**RE: AUTOMOTIVE REPAIR BUSINESS (K19-D107) ENGINEER'S  
CERTIFICATION FOR CERTIFICATE OF OCCUPANCY APPROVAL.  
ENGINEER'S CERTIFICATION STAMP DATED 10-3-95.**

RE: DRAINAGE PLAN FOR AUTOMOTIVE REPAIR SHOP (K19-D107)  
ENGINEER'S STAMP DATED 2/21/95.

## GRADING AND DRAINAGE PLAN

## AUTOMOTIVE REPAIR BUSINESS

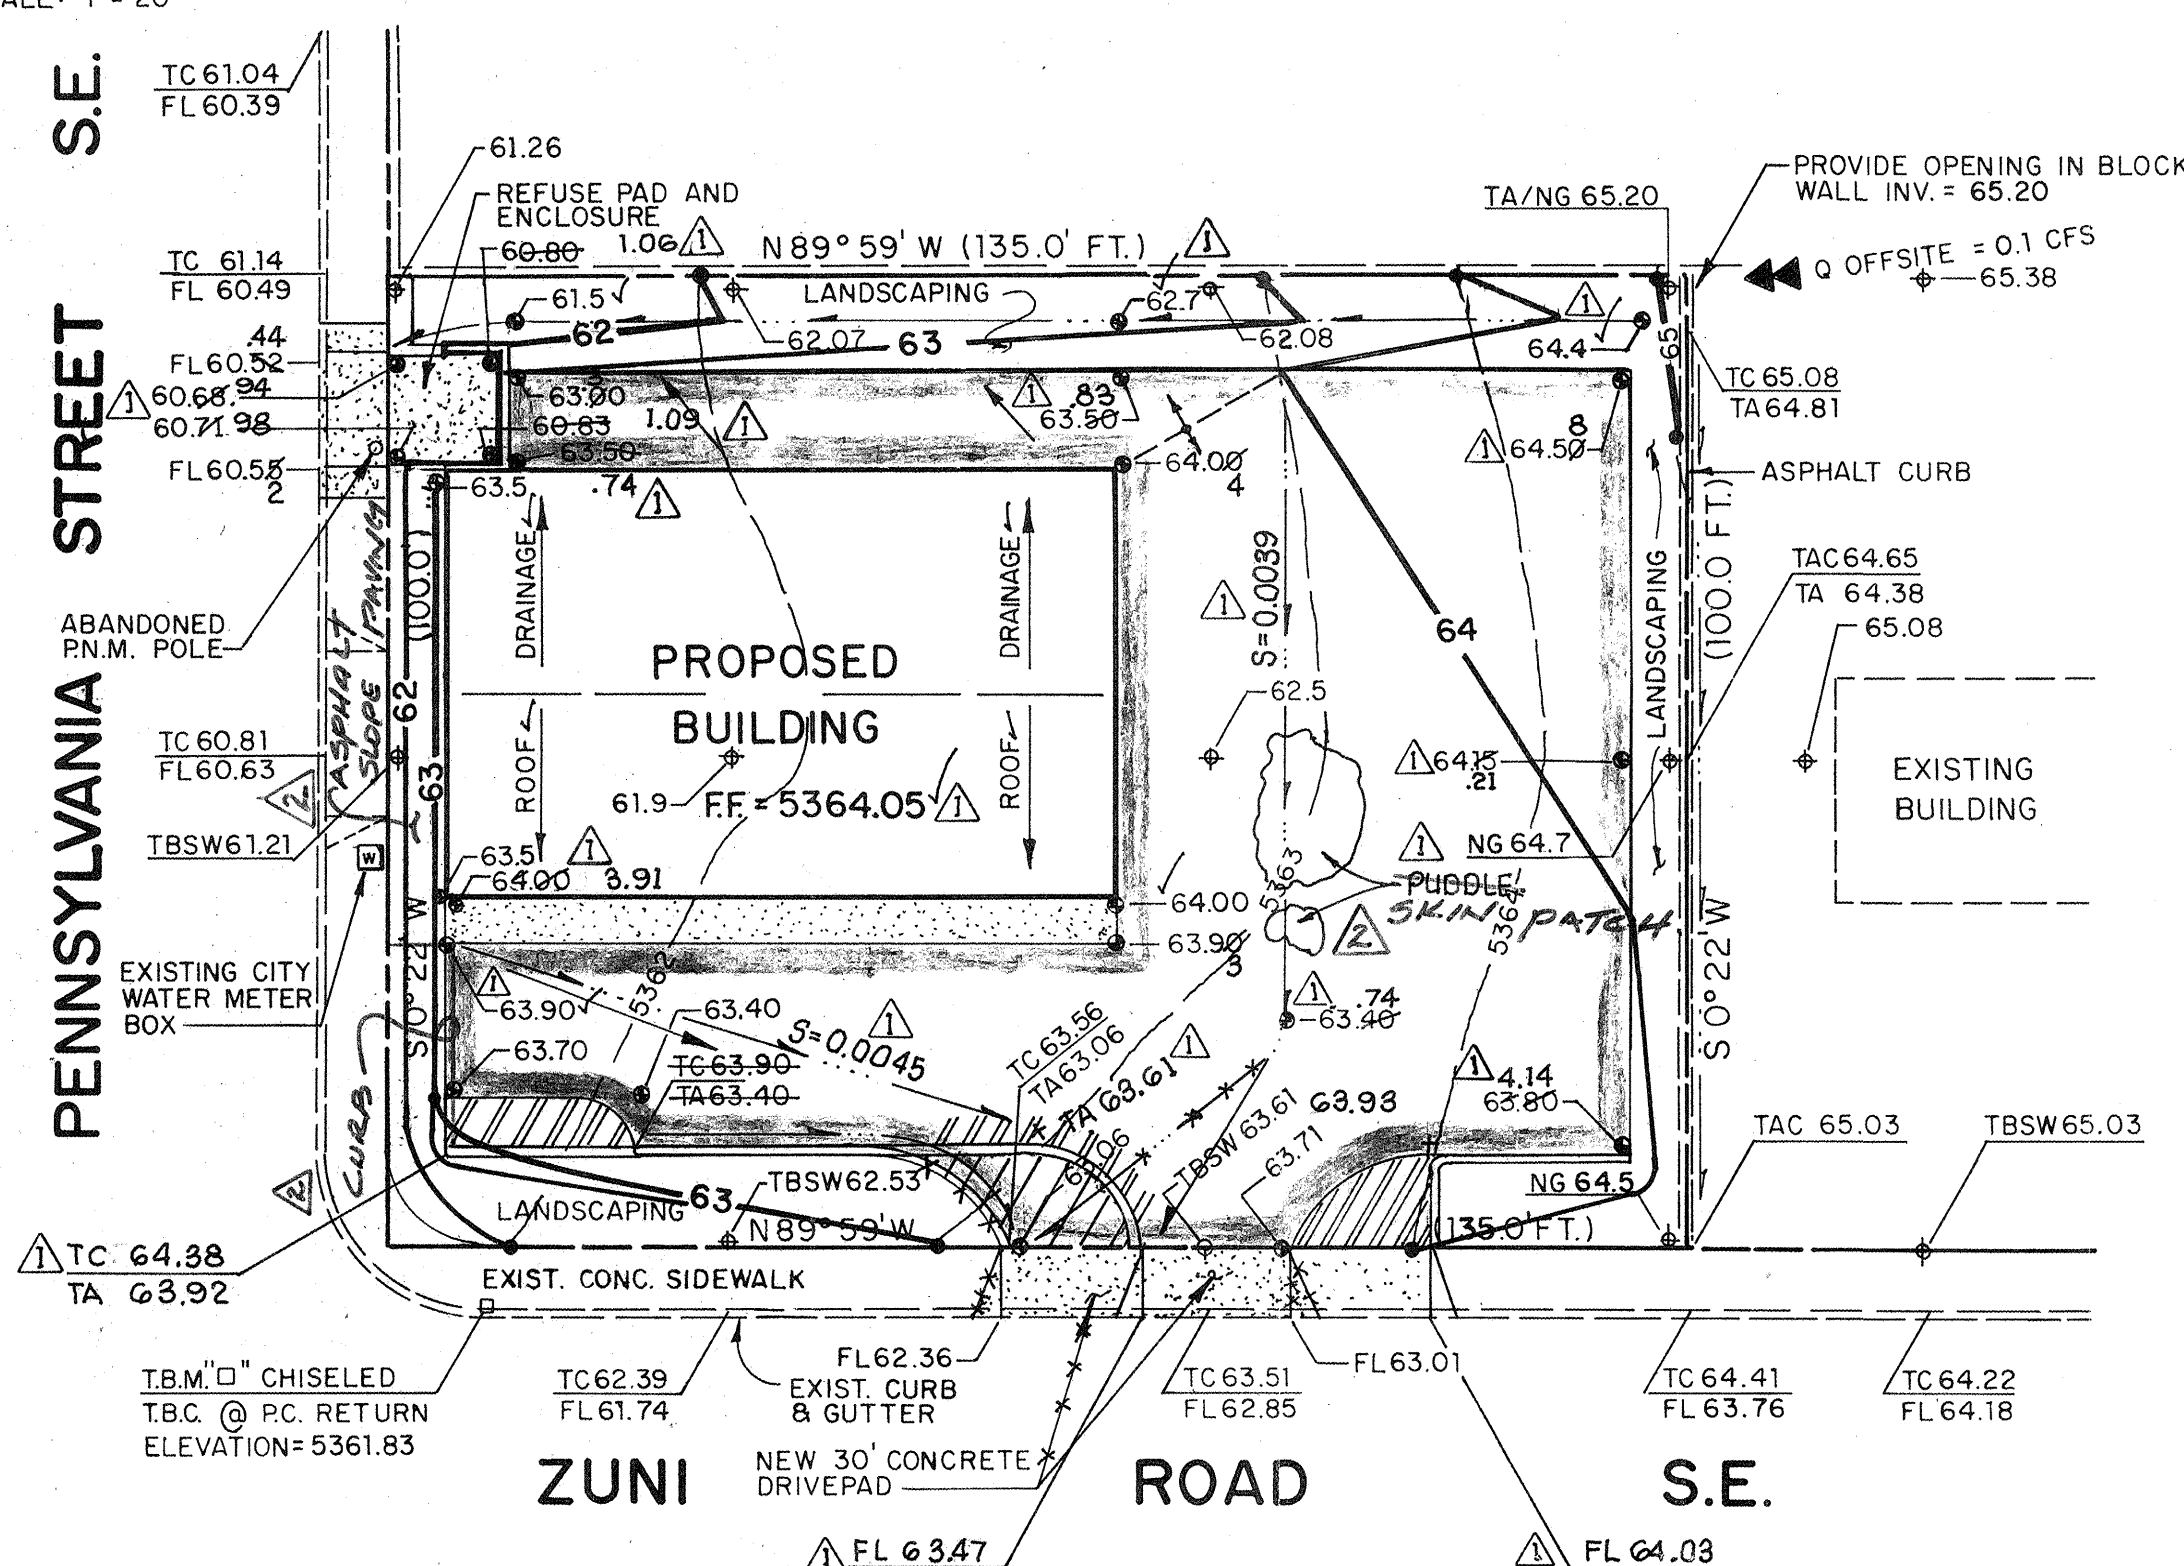
Based upon visual site inspection on October 02, 1995, the following corrections have been made:

1. The downspout at the southwest corner of the building has been redirected to discharge toward the parking lot as opposed to being directed toward the public sidewalk.
2. The asphalt slope paving along the west side of the building has been shown by Revision 2.
3. The areas within the asphalt paving where runoff was being contained in "bird baths" have been "skin patched" to the satisfaction of the Owner.

As indicated by the as-built information shown hereon, the Automotive Repair Business has been constructed in substantial compliance with the approved Grading Plan except for two areas, as shown in the plan, in which water puddles. Issuance of a Temporary Certificate of Occupancy is recommended until these two low areas are skin patched with asphalt. With the completion of the skin patch, issuance of a Permanent Certificate of Occupancy will be recommended. The as-built information has been obtained by me or under my direct supervision and is true and correct to the best of my knowledge and belief.

It is based upon the information presented above that acceptance of this project and issuance of a Permanent Certificate of Occupancy are hereby recommended.
